Access Compliance Report

Public Rights-of-Way

(Curb Ramps)

Intersection ID: 16880	Main Street: SELWYN_AV	Cross Street: WESTFIELD_RD	Location: SW
ADA ID: 87FA121AC10D	Ramp Type: Directional1	Initial Pass/Fail: Pass	Overall Compliance: No
Severity Score: 2.5			
Codes/Mitigation Info/Possible Solution		Field Measurements/Component Compliance

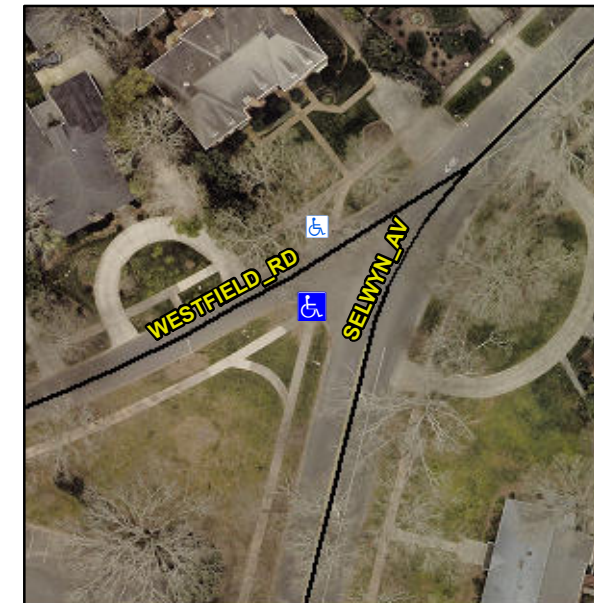
Remove & Replace Detectable Warning System.

R305.1.4
